Agenda
Hailey Planning and Zoning Commission
Monday, May 4, 2026
5:30 p.m.

FINDINGS OF FACT, CONCLUSIONS OF LAW AND DECISION

On April 20, 2026, the Hailey Planning and Zoning Commission considered and approved a Design Review Application, submitted by East Oakland International, LLC, and represented by Sage Sauerbrey, owner of Bigwood Tiny Homes, for the construction of a 3,436 square foot residential addition to an existing commercial building located at 400 N. Main Street (Lot 18-20, Block 57, Hailey Townsite) within the Business (B), Downtown Residential Overlay (DRO), and Townsite Overlay (TO) Zoning Districts.

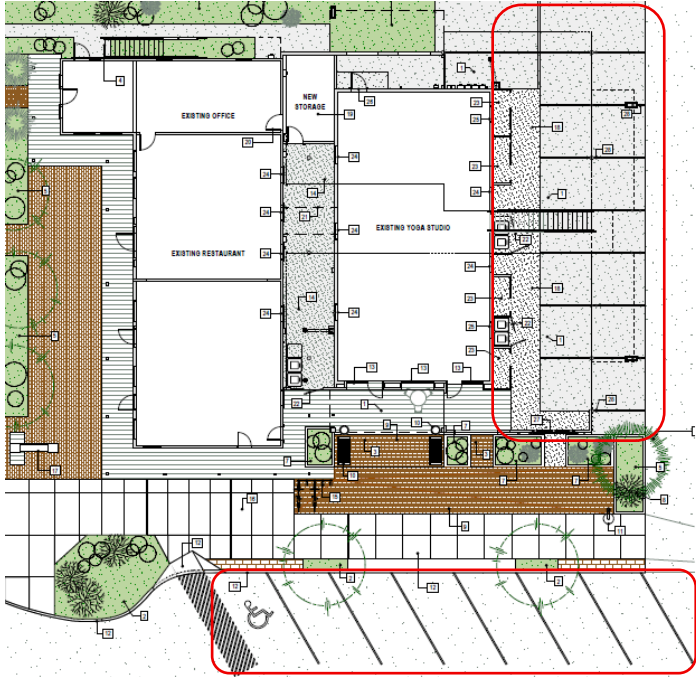
The Planning and Zoning Commission continued the hearing from March 16, 2026, to April 20, 2026, and recommended that the Applicant amend and/or clarify the following:

- A civil plan showing details around drainage, site grading, utilities, and ROW improvements.
- Exterior lighting temperature reduction (no greater than 3,000 kelvin)
- Accessibility route from onsite parking across the site and to the commercial entrance
- Information on increased insulation for new addition
- Onsite bike storage
- Fencing and landscaping along shared northern property line. The property owner to the North has some concerns about the existing fence's condition as well as the landscaping to the north.

The Applicant submitted amended plans which addressed the Commission's concerns, and any further discussion has been noted herein

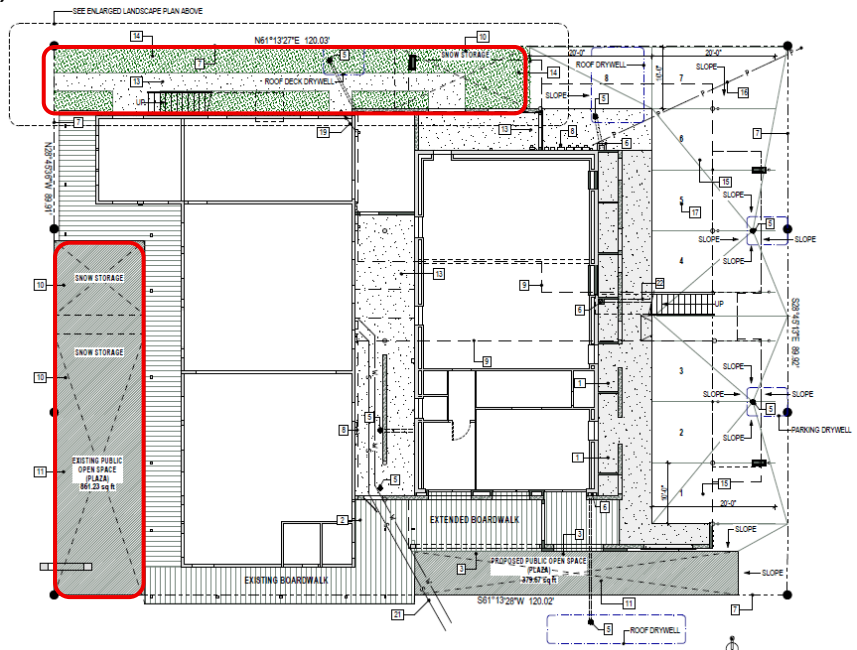
<input checked="" type="checkbox"/>	<input type="checkbox"/>	<input type="checkbox"/>	17.06.080(A)1h	<p>h. Access to on-site parking shall be from the alley or, if the site is not serviced by an alley, from a single approach to the street to confine vehicular/pedestrian conflict to limited locations, allow more buffering of the parking area and preserve the street frontage for pedestrian traffic.</p> <p><i>Staff Comments</i> The site is serviced by one (1) public street and an alley: E. Silver Street and the existing alley. The onsite parking area can be accessed via the existing alley, which connects to E. Silver Street. <i>Findings: Compliance. This standard has been met.</i></p>
<input checked="" type="checkbox"/>	<input type="checkbox"/>	<input type="checkbox"/>	17.06.080(A)1i	<p>i. Snow storage areas shall be provided on-site where practical and sited in a manner that is accessible to all types of snow removal vehicles of a size that can accommodate moderate areas of snow.</p> <p><i>Staff Comments</i> The proposed snow storage area is located along the eastern side of the building within the existing open space (plaza), as well as adjacent to the northern property line. The improved hardscape for the project is 831 square feet which requires 208 square feet of snow storage. Onsite snow storage areas are proposed in the amount of 227 square feet. New heated drain lines from the proposed apartment roofs will be designed to gather both snow and stormwater on the roofs of the new apartments as well as the roof top deck of the commercial space to be piped from the drains to a designated drywell. The new roof top gathering</p>

and piping allows for the stormwater to be evenly distributed among the existing drywells. This standard has been met.

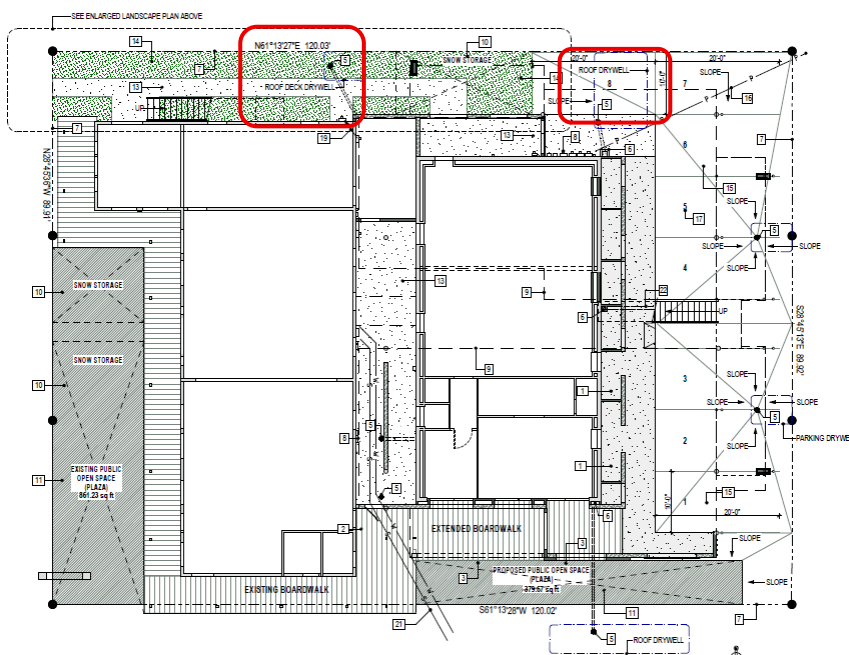
Staff Comments	<i>Proposed landscaping varies with a combination of existing trees, planter boxes, and existing shrubs, and the addition of decorative grasses to soften the site, as well as to create visual interest. Findings: Compliance. This standard has been met.</i>
<input checked="" type="checkbox"/>	<input type="checkbox"/>	<input type="checkbox"/>	17.06.080(A)4g	g. Storm water runoff should be retained on the site wherever possible and used to irrigate plant materials.
			Staff Comments	<i>New heated drain lines from the proposed apartment roofs as well as the commercial space are designed to gather both snow and stormwater to be piped from the drains to a designated drywell.</i>
				 <p>The diagram is a detailed site plan showing building footprints, boardwalks, and landscaping. Key features include: <ul style="list-style-type: none"> Two red boxes highlighting 'ROOF DECK DRYWELL' locations on the upper portion of the site. Another red box highlighting a 'ROOF DRYWELL' location on the right side. Two 'SNOW STORAGE' areas on the left side. 'EXISTING BOARDWALK' and 'EXTENDED BOARDWALK' along the bottom and left edges. 'EXISTING PUBLIC OPEN SPACE PLAZA' and 'PROPOSED PUBLIC OPEN SPACE PLAZA' at the bottom. 'PARKING DRYWELL' on the right side. Various slope indicators and dimensions (e.g., N61°13'27"E 120.03', S61°19'28"W 120.02'). </p>

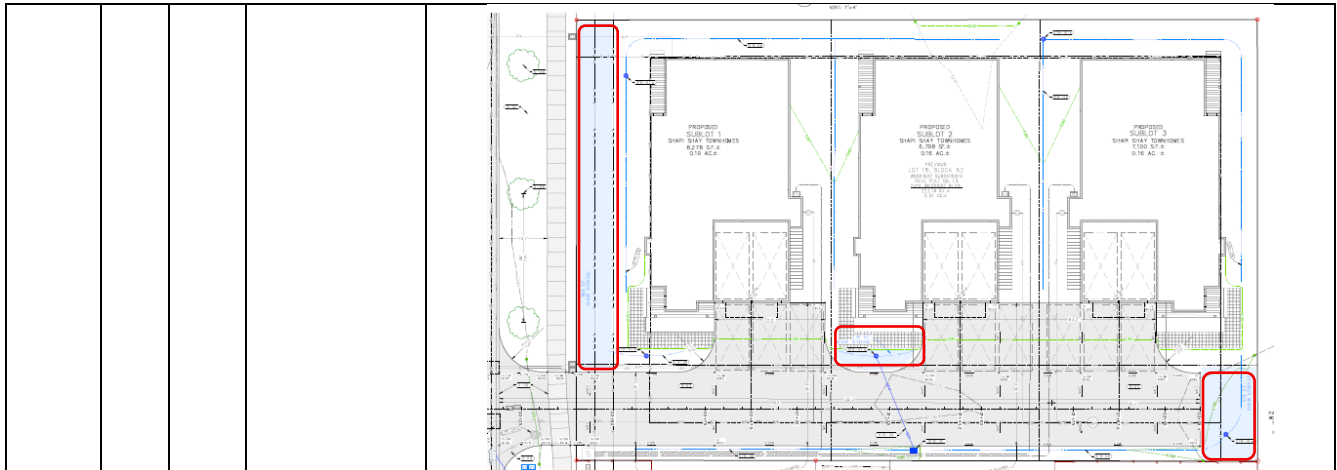
<i>Staff Comments</i>	<i>Onsite snow storage areas are proposed for this parcel in the amount of 1,500 square feet, including the access aisles and driveways. The improved hardscape for the project is 5,250 square feet which requires 1,313 square feet of snow storage. The Applicant exceeds this requirement with 1,500 square feet of onsite snow storage. Findings: Compliance. This standard has been met.</i>

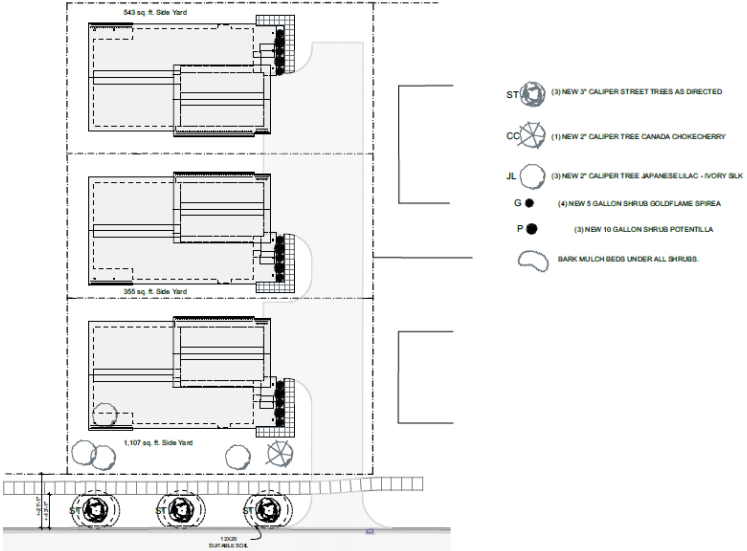
Compliant			Standards and Staff Comments	
Yes	No	N/A	City Code	City Standards and Staff Comments
<input checked="" type="checkbox"/>	<input type="checkbox"/>	<input type="checkbox"/>	17.06.080(A)4a	a. Only drought tolerant plant species and/or xeriscape specific plant materials shall be used, as specified by the Hailey Landscaping Manual or an approved alternative.
			<i>Staff Comments</i>	<i>The Applicant is proposing drought tolerant native compatible plant materials. All new shrubs and trees are to be drought tolerant species and hardy to the zone 4 environment. All planted areas are to be professionally maintained.</i> <ul style="list-style-type: none"> - One (1) new 2" caliper Canada Chokecherry tree - Three (3) new 2" caliper Japanese Lilac- Ivory Silk trees - Four (4) new 5-gallon Goldflame Spirea shrubs - Three (3) new 10-gallon Potentilla shrubs - Exact sub-species of trees and shrubs listed TBD based on availability and

<p>at the recommendation of the landscaper.</p> <ul style="list-style-type: none"> - Bark beds to surround all shrubs. - Three (3) new 3" caliper street trees as directed. American Elm which was recommended Street Trees from the Tree Committee at their meeting in April. - All areas not paved or covered by planting beds to be grass. Landscaper to verify drought tolerant native mix suitable to zone 6.  <p><i>Findings: Compliance. This standard has been met.</i></p>
<input checked="" type="checkbox"/>	<input type="checkbox"/>	<input type="checkbox"/>	<p>17.06.080(A)4b</p> <p>b. All plant species shall be hardy to the Zone 4 environment.</p> <p><i>Staff Comments</i> Plant materials will be appropriate for the Zone 4 environment. <i>Findings: Compliance. This standard has been met.</i></p>
<input checked="" type="checkbox"/>	<input type="checkbox"/>	<input type="checkbox"/>	<p>17.06.080(A)4c</p> <p>c. At a minimum, a temporary irrigation system that fully operates for at least two complete growing seasons is required in order to establish drought tolerant plant species and/or xeriscape specific plant materials. Features that minimize water use, such as moisture sensors, are encouraged.</p> <p><i>Staff Comments</i> A temporary irrigation system that fully operates for at least two (2) complete growing seasons will be installed to establish drought tolerant plant species. Irrigation features that minimize water use, such as moisture sensors, are encouraged. The irrigation systems shall not be placed against the pavement; they shall be positioned in a way where they will not spray water on the pavement or other hard-scape areas. <i>Findings: Compliance. This standard has been met.</i></p>
